## NOVI CORPORATE CAMPUS PARCEL 1 JSP18-43

Consideration of the request of Dembs Development for Preliminary Site Plan and Storm Water Management Plan approval for a new 93,320 square foot Research/Development/Office building. The subject property contains 6.6 acres and is located in Section 9, north of Twelve Mile Road and east of West Park Drive, in the I-1, Light Industrial District.

## PLANNING REVIEW

**Review Date:** September 18, 2018  
**Review Type:** Preliminary Site Plan  
**Project Name:** Novi Corporate Campus Parcel 1, JSP18-43  
**Location:** 45900 Twelve Mile; North of Twelve Mile Road, East of West Park Drive  
**Plan Date:** 8/21/18  
**Prepared by:** Lindsay Bell, Planner  
**E-mail:** [lbell@cityofnovi.org](mailto:lbell@cityofnovi.org) **Phone:** 248.347.0484

Title:  
**Landscape Plan**

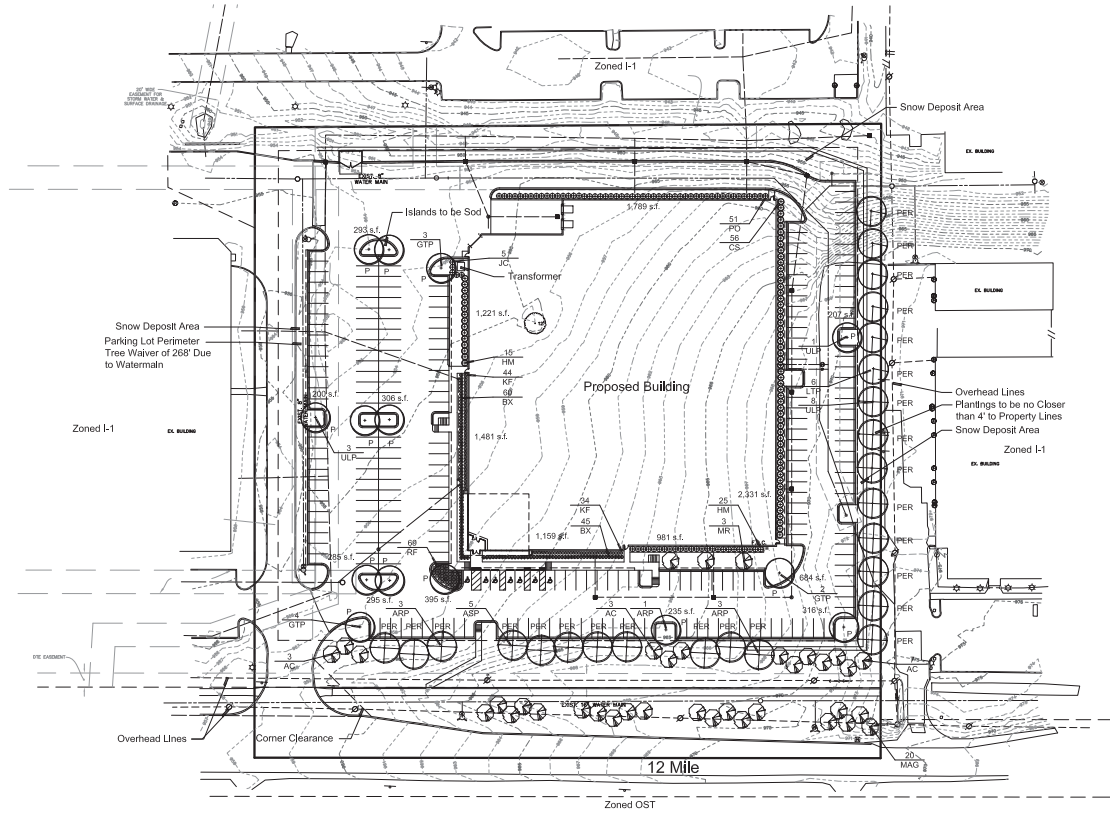
1. The required greenbelt width is provided.
2. **Based on the frontage, less the width of the access way, the applicant should provide**

3. The required undulating berm, with a 3 foot minimum height and 3' crest, is not provided.  
**Please provide the berm.**

1. Based on the frontage, 10 canopy trees are required. 20 subcanopy trees are provided.
2. Since there are overhead wires, subcanopy trees are correctly used, but the requirement is only 1.5 subcanopy trees per canopy tree, so the total number of trees provided may be reduced to 15 if desired.
3. Please get approval from the Road Commission for Oakland County for the street trees. If they disallow any of them, please provide us a copy of their denial.

1. Based on the vehicular use areas, 2,710 sf of islands and 14 trees are required. 3,216 sf of islands and 14 trees are provided.
2. **Please add additional trees to all endcap islands and interior islands used to break up parking lots into bays of 15 or fewer spaces.**
3. **Each tree must have 200 sf of area in an island. Please move trees as necessary to meet this requirement.**
4. **If proposed utility lines create conflicts with required trees, the utilities should be re-aligned to remove the conflict.**

1. Based on parking lot perimeter, 24 trees are required and 25 trees, including 11 greenbelt trees within 15 feet of the parking lot, which are double-counted as allowed by the ordinance, are provided.
2. Parking lot perimeter trees are also required along the 510lf north side of the north access drive. **Please provide the required 15 trees along that driveway.**
3. A Planning Commission landscape waiver is requested for the 8 perimeter trees that aren't provided along the western island due to a conflict with an existing water main. *While the applicant is in effect creating their own hardship with the layout, to avoid that water main would chew up a lot of real estate. As it is internal to the site, the landscape waiver is supported by staff, but trees need to be added to the endcap islands for those parking bays.*

1. Based on the building perimeter, less access areas, 8,824 sf of foundation landscape area is required, and 8,962 sf is provided.
2. **Please provide something other than grass for the large area in front of the HMs at the northwest corner of the building.**
3. Over 90% of the building facing Twelve Mile Road is landscaped, exceeding the 60% requirement.

**Please add additional tree species to meet the Landscape Design Manual's (Sec 4) standards for diversity (25% for a genus, 15% for a species).**

**Please revise the notes provided per the instructions on the landscape chart.**

1. Provided.
2. **Please add the clearance triangle per the RCOC requirements and keep all trees outside of it.**
